Addendum No 1:
PROPOSED COSTCO OFFICE EXPANSION,
415 WEST HUNT CLUB ROAD
CITY OF OTTAWA
TRANSPORTATION IMPACT
ASSESSMENT REPORT (June 20th, 2024)

The following Addendum document was produced to provide refinements to the above TIA document to account for alterations done to the Site Plan

DRAWING TITLE: SITE PLAN

Addendum No A-1:
PROPOSED COSTCO OFFICE EXPANSION,
415 WEST HUNT CLUB ROAD
CITY OF OTTAWA
TRANSPORTATION IMPACT
ASSESSMENT REPORT (June 20th, 2024)

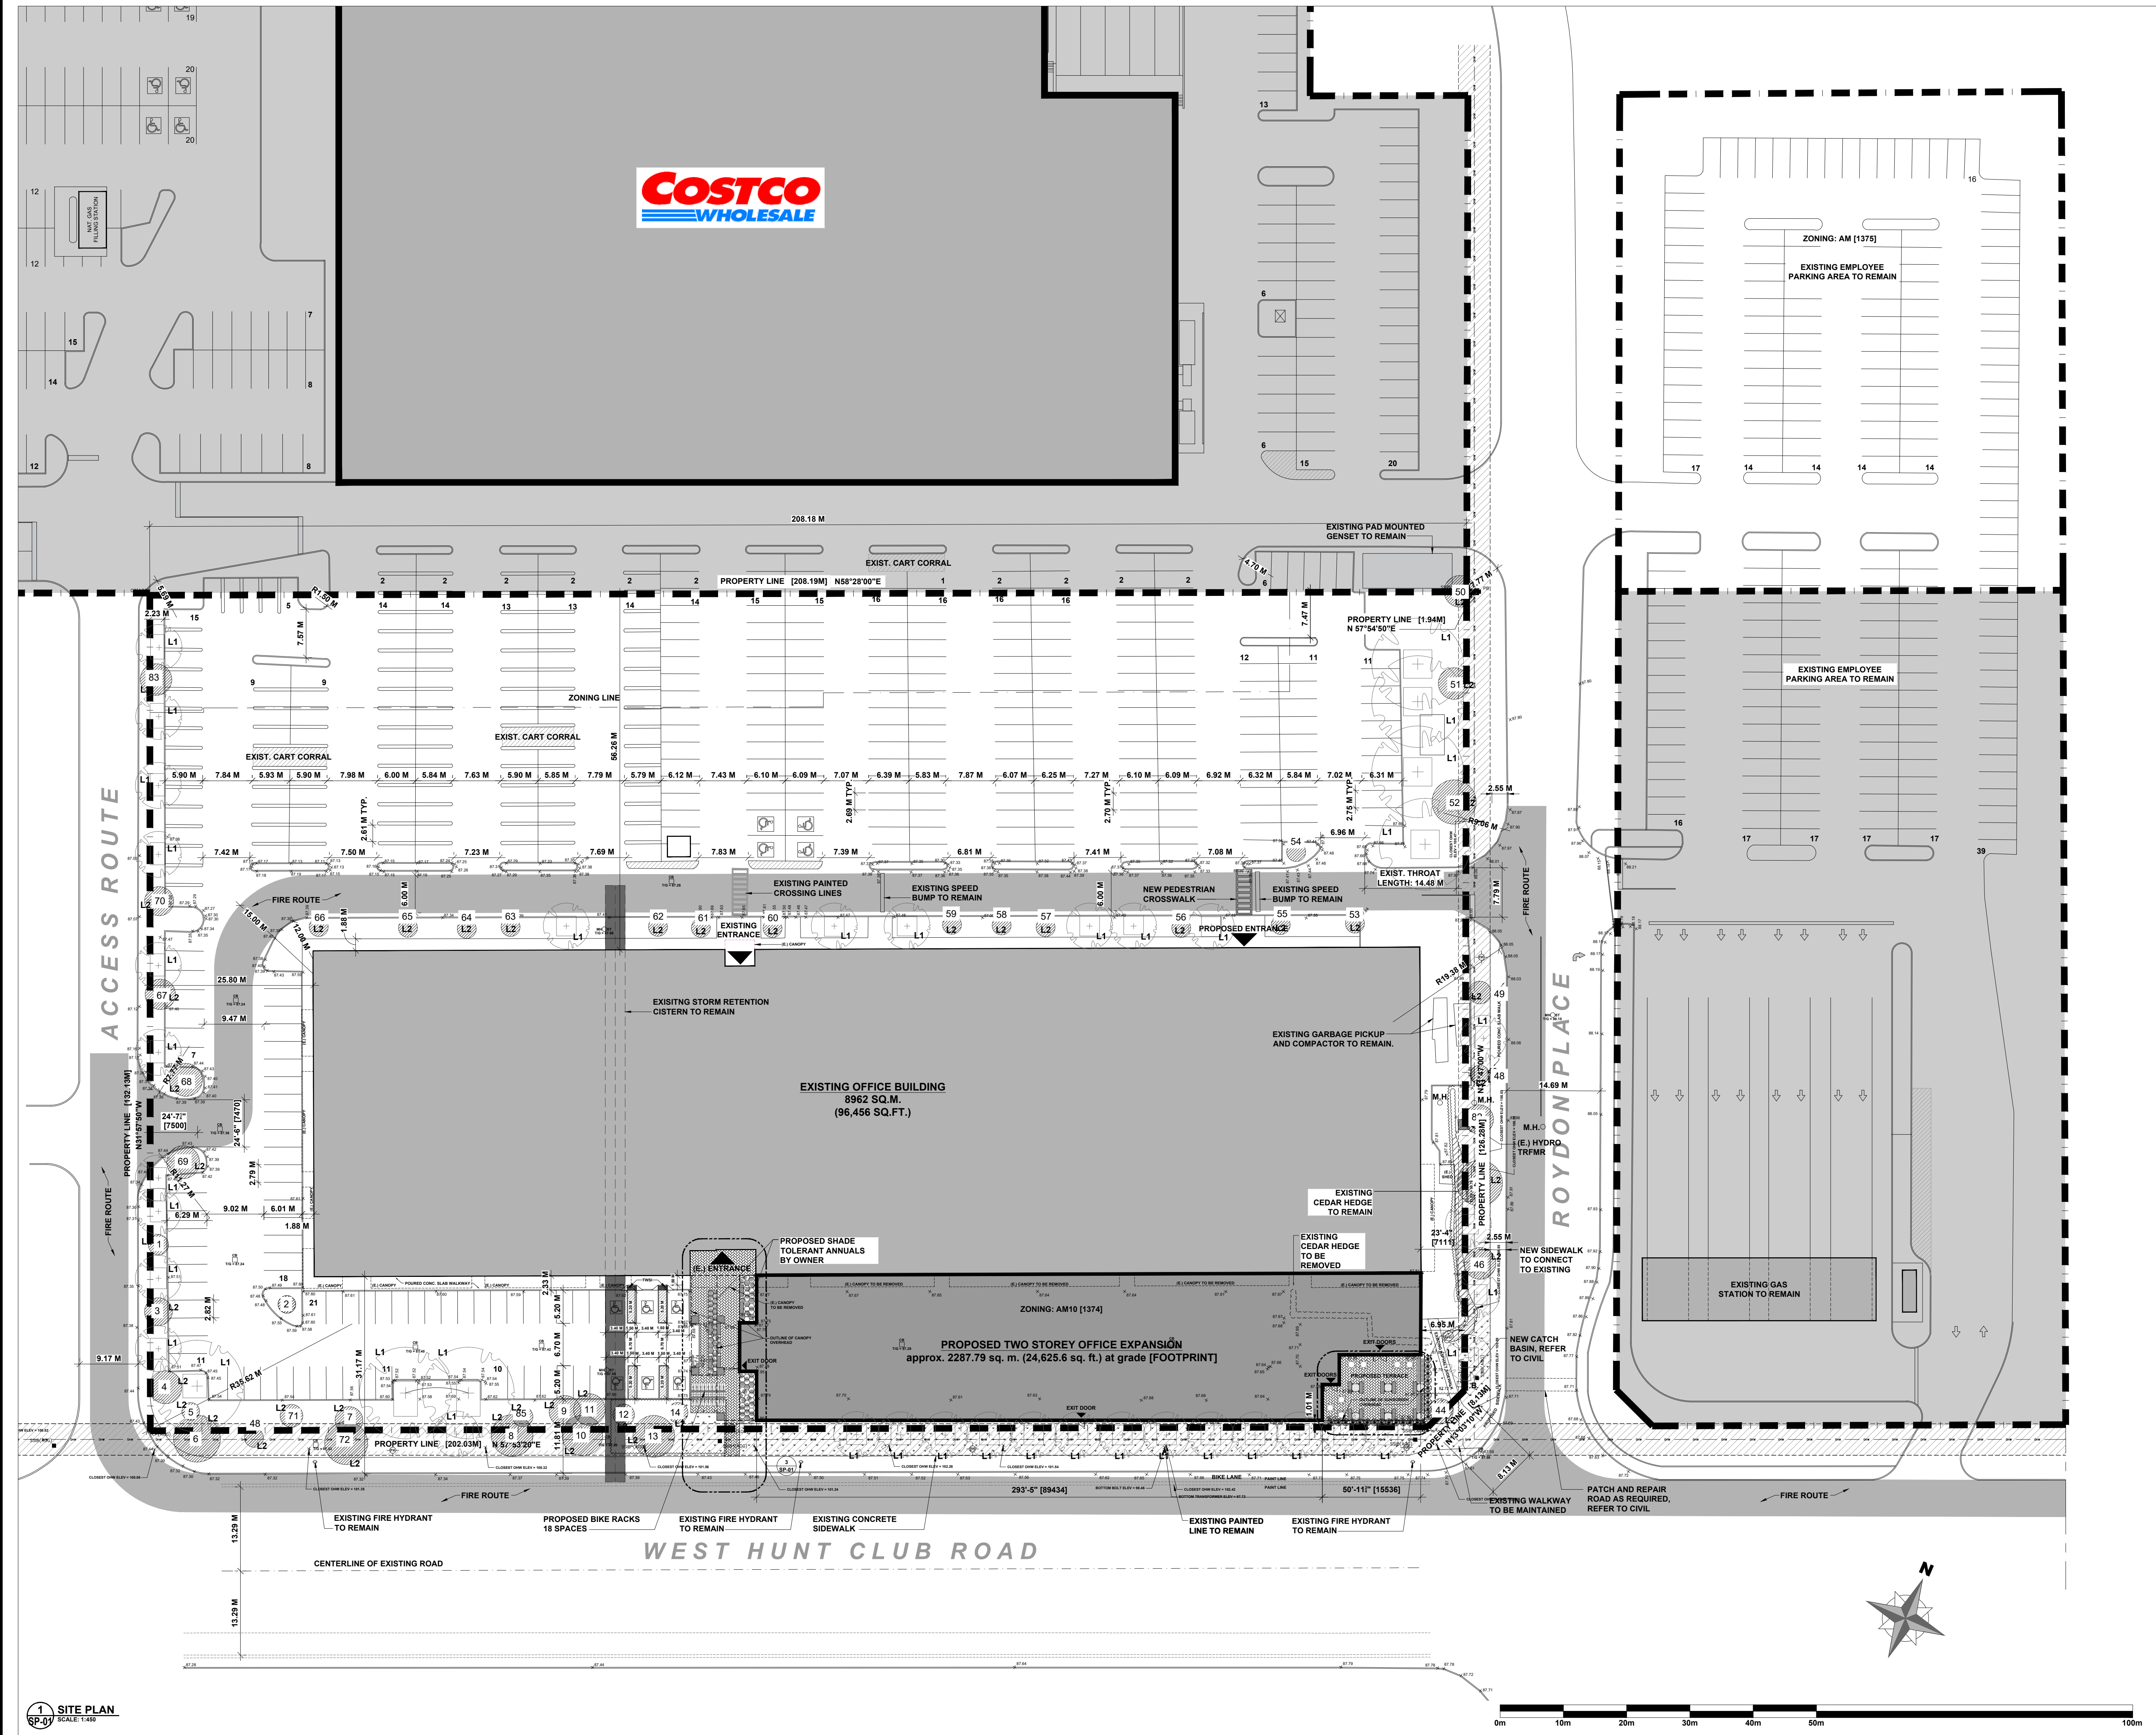
The new Site Plan dated (August 23rd, 2024) is illustrated within Annex “A”.

The changes to the site plan effected the following:

- The total gross floor area (GFA) of the proposed addition to the existing corporate headquarters building;
- The number of total available parking stalls;
- The location of bicycle parking;
- A new proposed pedestrian crossing at the north façade of the building; and
- The timing of occupancy.

The gross floor area (GFA) of the “proposed building addition” has decreased by approximately 19.5 percent, from 4,266.4 m² to 3,571.39 m². In terms of the entire total building area the total GFA of the entire building decreased by 3.5% (from 12,994.4 m² to 12,533.39 m²). The change has occurred due to alterations to the permit floor plan.

The southern parking stalls were re-worked to meet AODA requirements and provide additional space for tree planting. This resulted in the provided parking stalls to decrease from 604 stalls to 602 stalls.

Table 4-2 described the bicycle parking requirements and provisions of the proposed expansion. The required parking based on the City of Ottawa parking rate has decreased from 18 bike stalls to 14 bike stalls. The site plan continues to providing 18 bike stalls, but they have been relocated from outside, west of the proposed new entrance to under a new proposed covered entrance area.

A new pedestrian link is proposed to be located on the north side of the building, across from the main employee entrance. The crossing would provide a safer delineated route for employees to cross the lane/roadway that abuts the north side of the HQ building linking the parking lot to the north of the HQ building.

SP-01

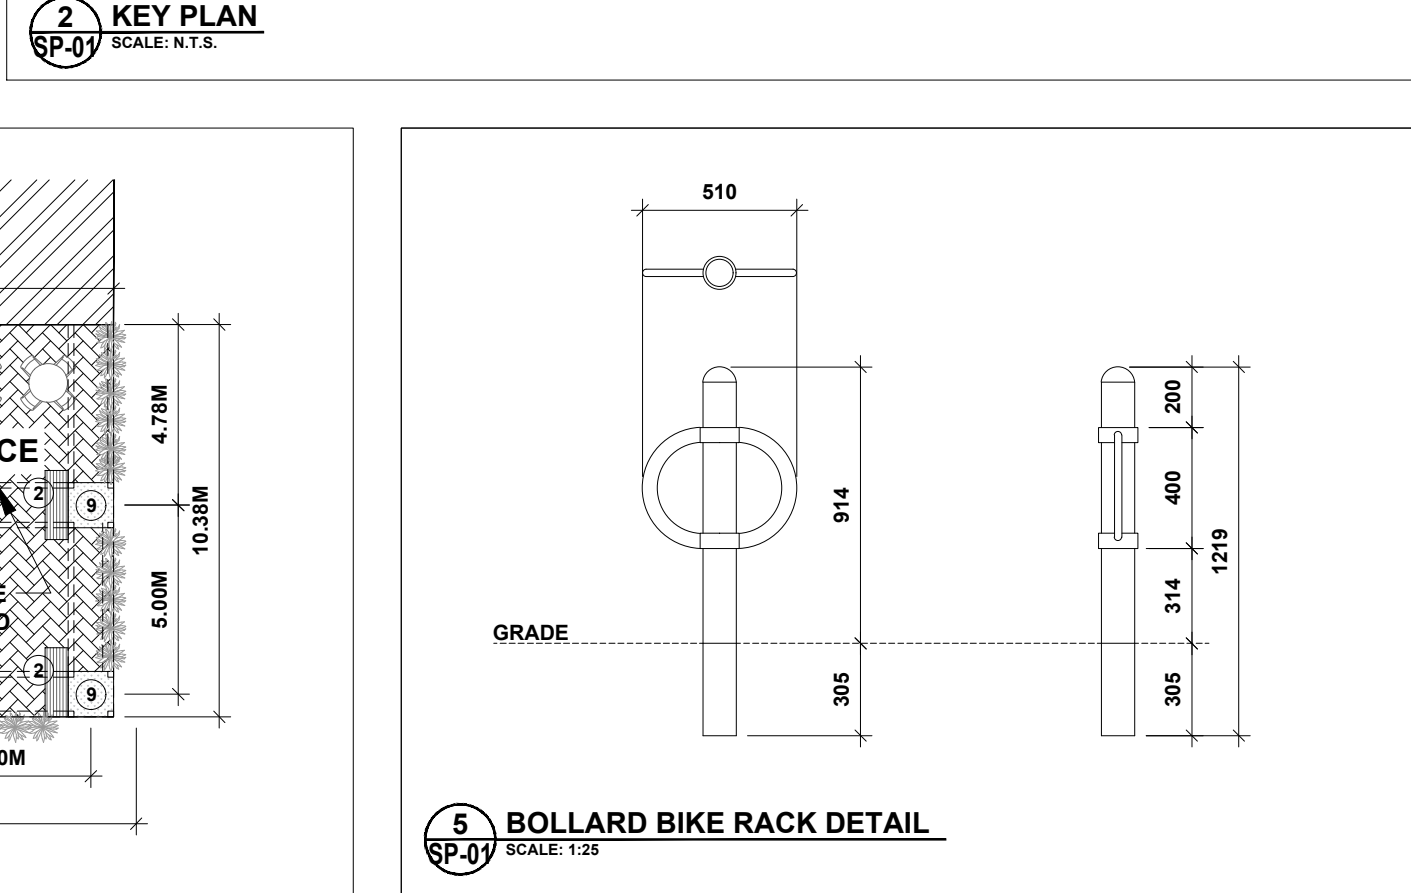
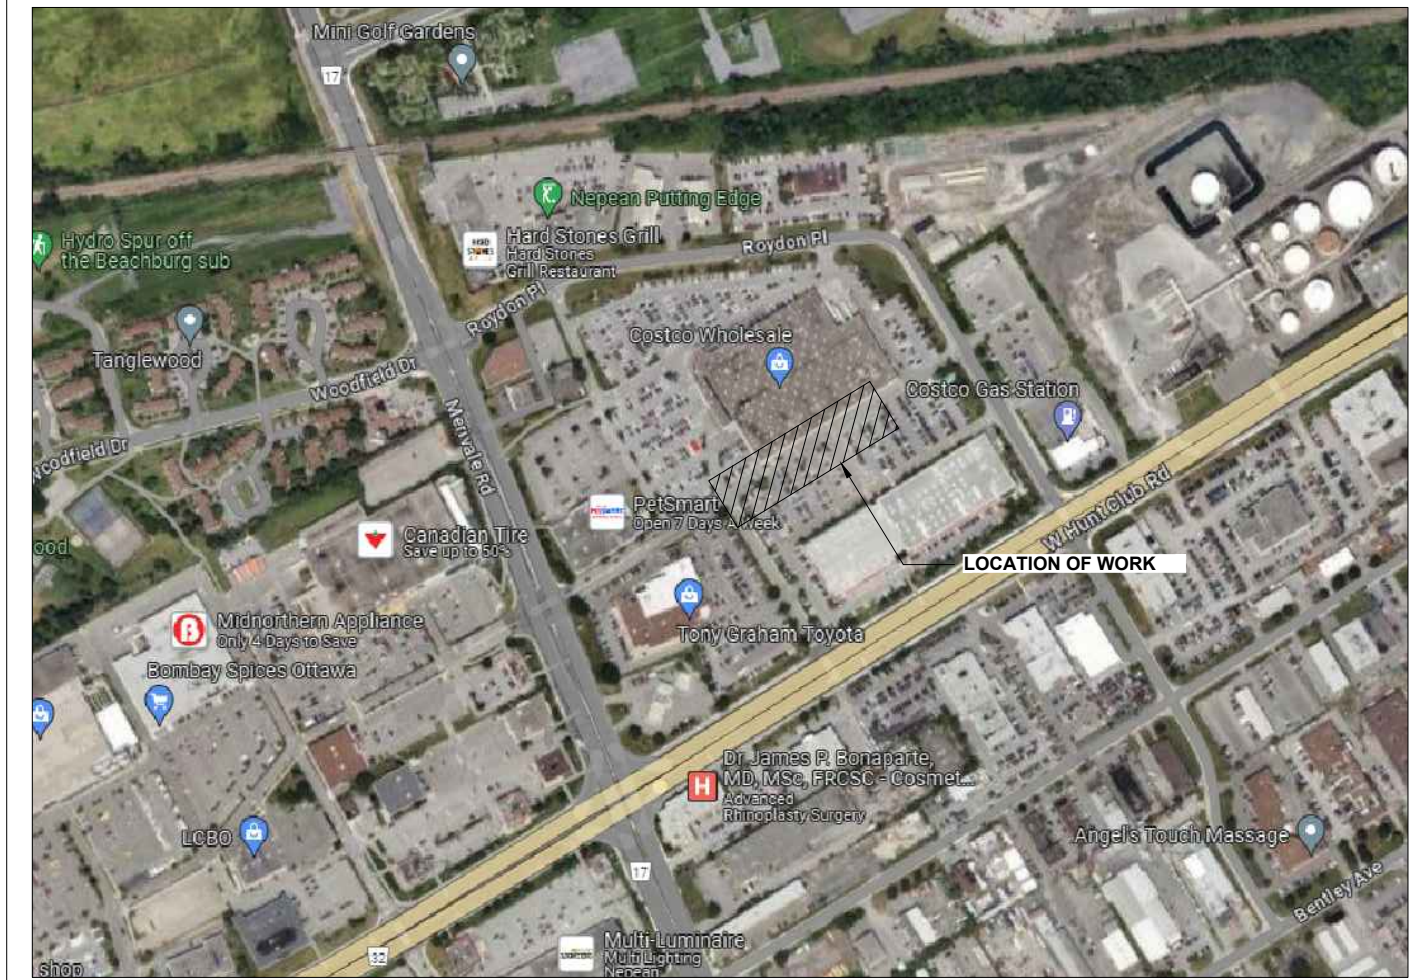
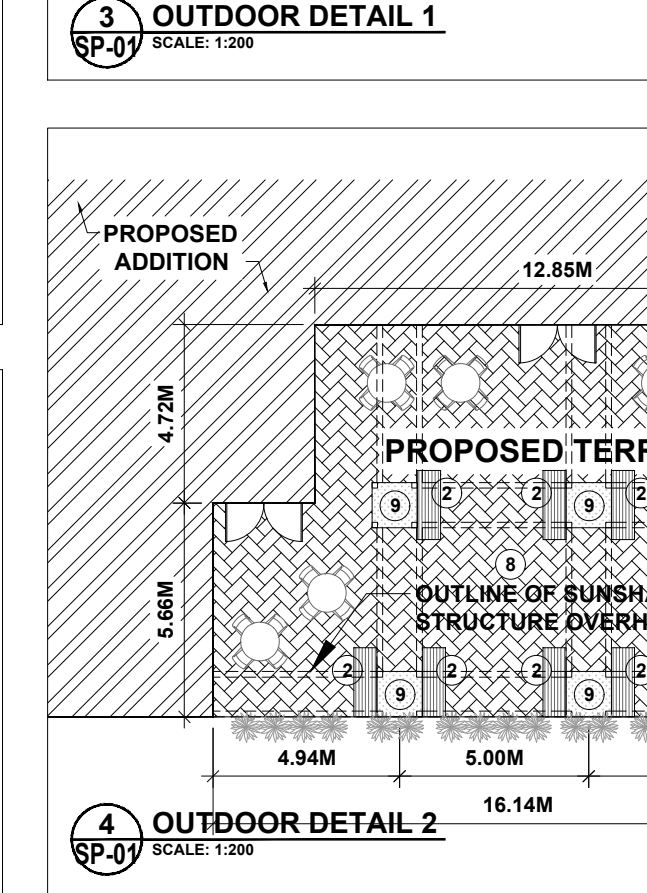
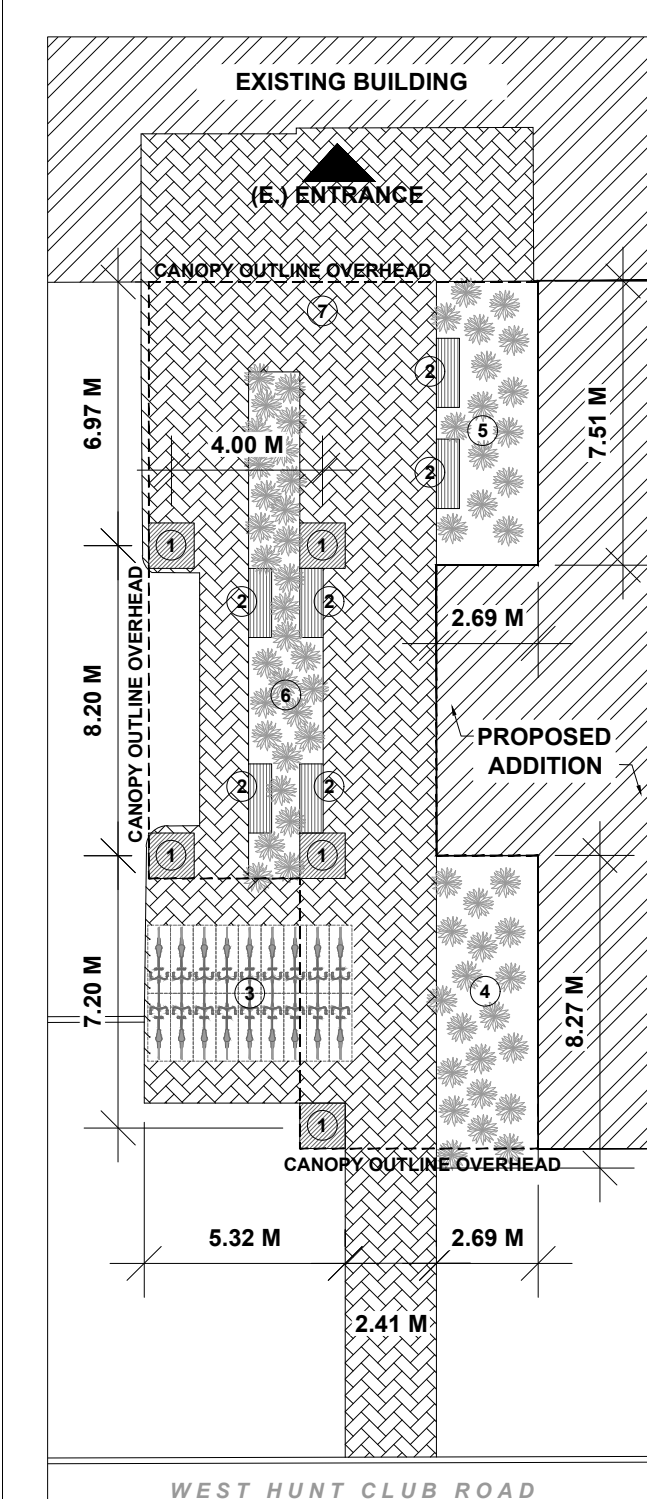
COMMENT: #7 - IDENTIFY LOCATION OF SNOW STORAGE

RESPONSE: #7 - SNOW TO BE REMOVED AND STORED OFF-SITE
